May 3, 2018

Product Change Notice - New thread length for trolley tab spacer kit screws

Fig.1

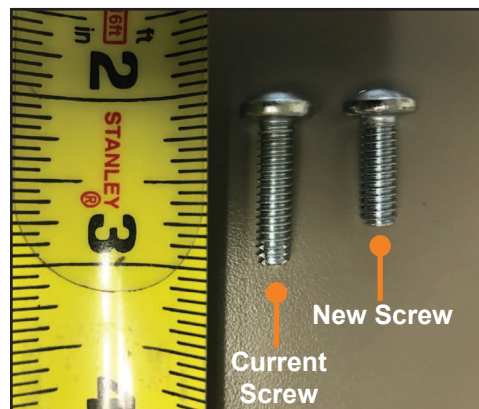
Please be advised we are making a change in thread length on the screws for our bunk lift trolley tab spacer kits from a 1" type - f screw to a $\frac{3}{4}$ " machine screw (Fig. 1). The change is being made to accommodate a new bunk lock bed lift.

Fig.2

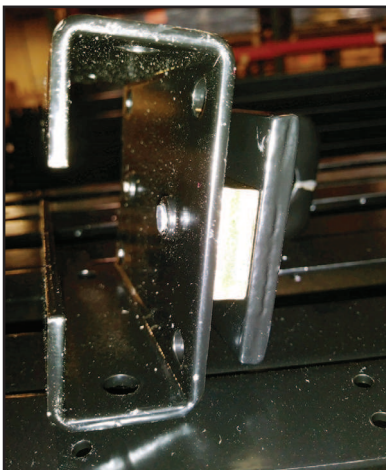
The screw with $\frac{3}{4}$ " thread protrudes one to two threads past the hole in the trolley tab, which is sufficient thread engagement (Fig.2). The longer 1" thread adds no additional benefit to the system.
